Variant FCC RF Test Report

APPLICANT : DELL Inc.
EQUIPMENT : Tablet PC
BRAND NAME : Dell
MODEL NAME : T01C; T01C003
TYPE NAME : T01C003
FCC ID : E2K-T01C003
STANDARD : FCC Part 15 Subpart C §15.247
CLASSIFICATION : (DTS) Digital Transmission System

REPORT NO.	VERSION	DESCRIPTION	ISSUED DATE
FR422417-01B	Rev. 01	This is a variant report for T01C; T01C003. The product equality declaration could be referred to Appendix B. Based on the similarity between two models, only the worst case of Radiated Spurious Emission from original test report (Sporton Report Number FR422417B) was verified.	Oct. 31, 2014

Product Equality Declaration

6. HW differences as below:

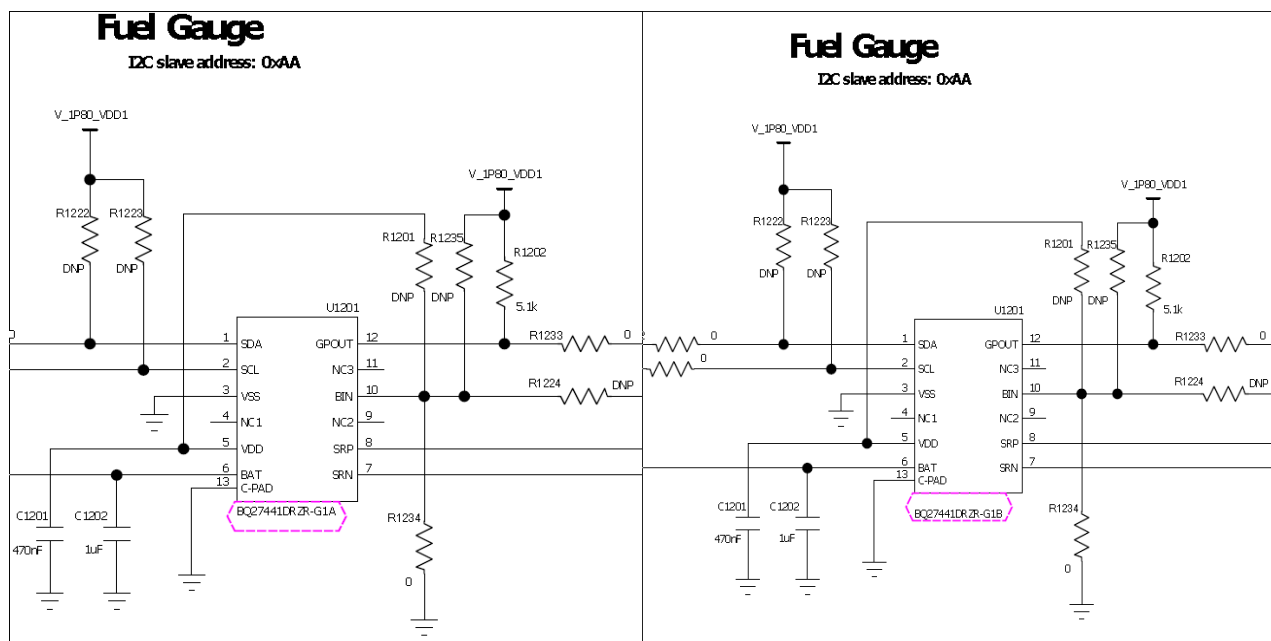
1. Fuel Gauge IC upgrade from BQ27441DRZR-G 1A to BQ27441DRZR-G1B.

2. BT/WIFI antenna matching optimization.

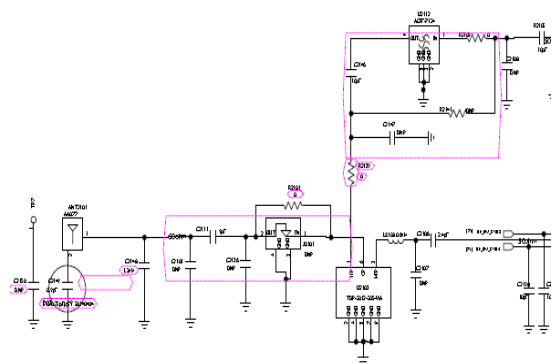
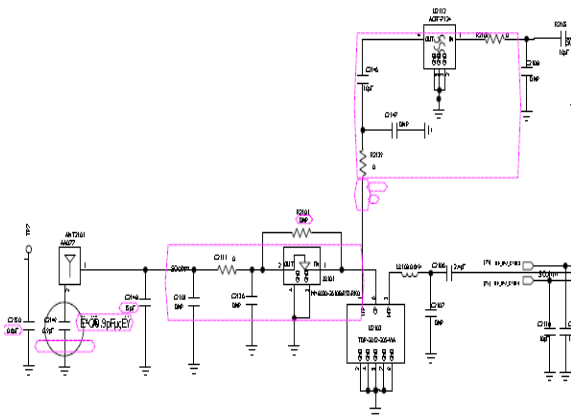
C2149 change from 0402 0.75 PF to 0402 0.9 PF;
 C2150 change from 0402 0.5 PF to 0402 DNP;
 C2148 change from 0402 9 PF to 0402 1.2NH;
 J2101 change from MM8030-2610B/RJ3/RK0 to DNP;
 R2101 change from DNP to 0201 0R.

3. Optimization of audio circuit.

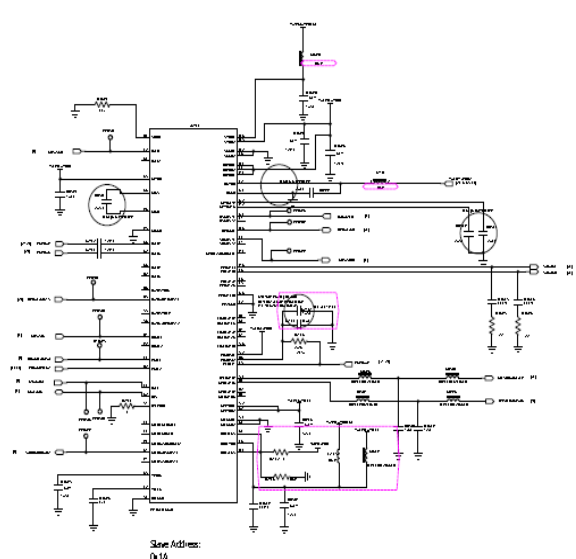
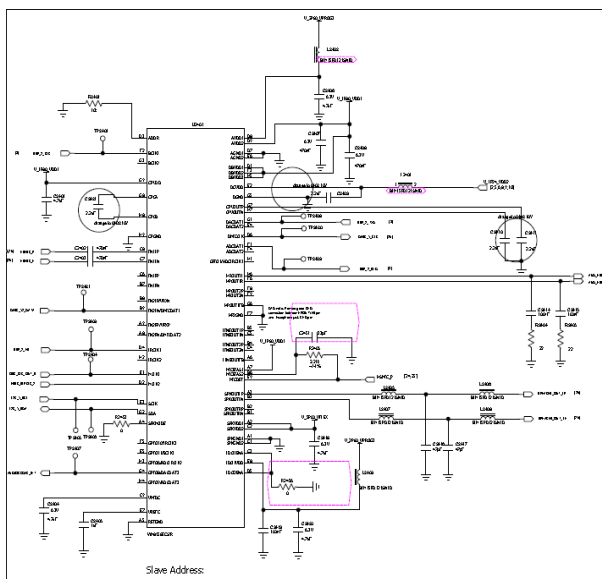
Add R2457 0R 0201 L2410;
 Delete R2456, L2401, L2402, L2409.

4. Optimization Headset interface circuit.

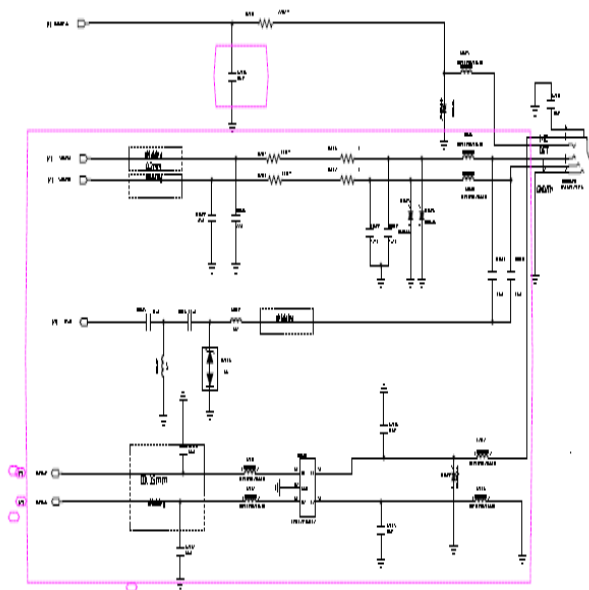
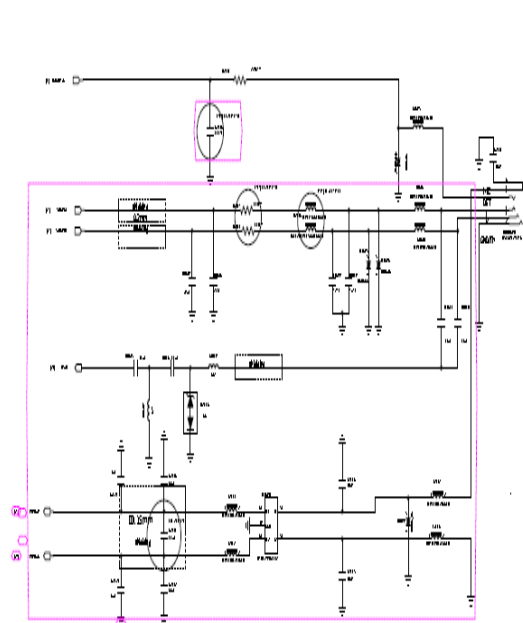
Add C2452 4.7uF 0402;
 R2506 change from 0R 0402 to BLM15AG601SN1D;
 R2507 change from 0R 0402 to BLM15AG601SN1D;
 C2506 change from 0201 DNP to 0201 100nF;
 R2504 change from 10R 0201 to 33R 0201;
 R2505 change from 10R 0201 to 33R 0201;
 Add C2515 33pF 0201.

5. Replacing the USB connector.

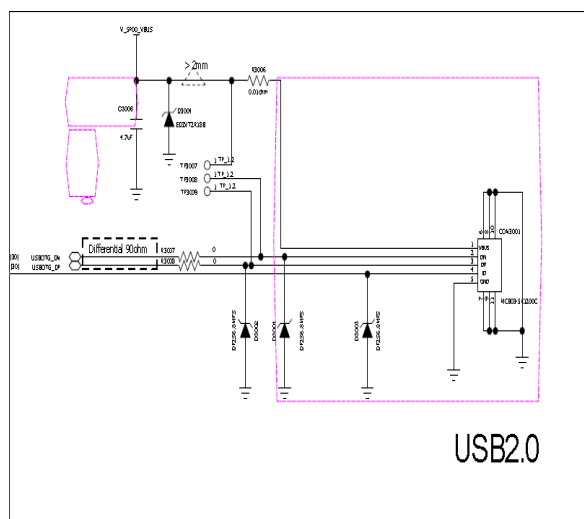
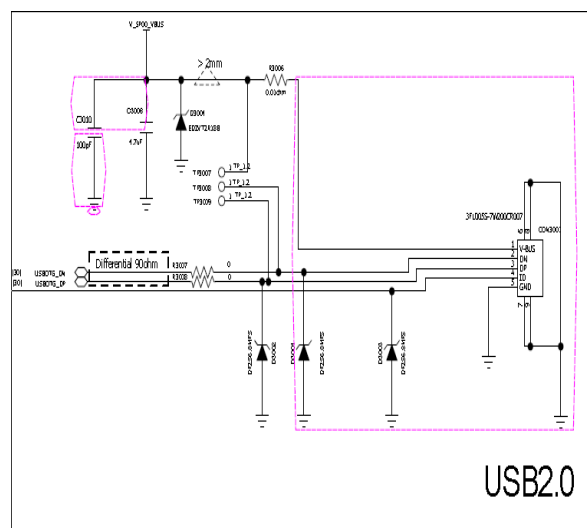
Connector changed from CON3001 MCB03-5K1200C to 3FU005S-7W200CR007.

6. Optimization of LED lamp control circuit.

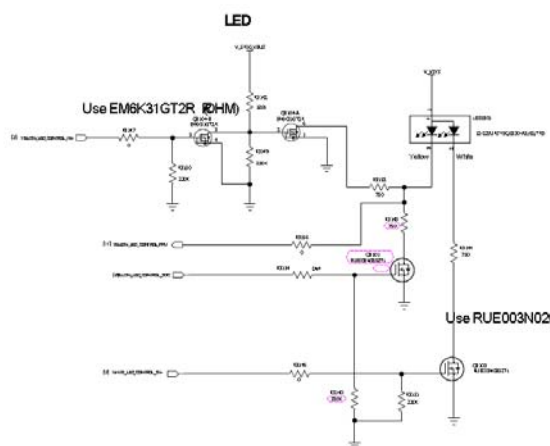
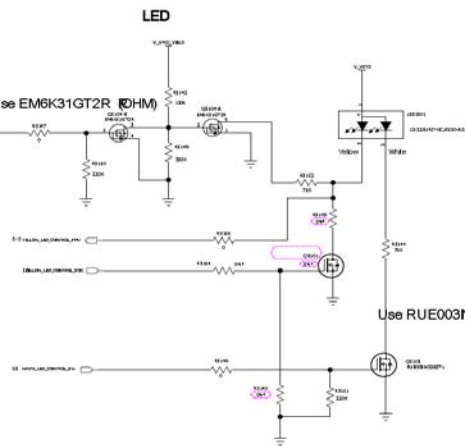
Q3101 change from RUE003N02GZTL to DNP;

R3148 change from 750 R to DNP;

R3140 change from 220K to DNP.
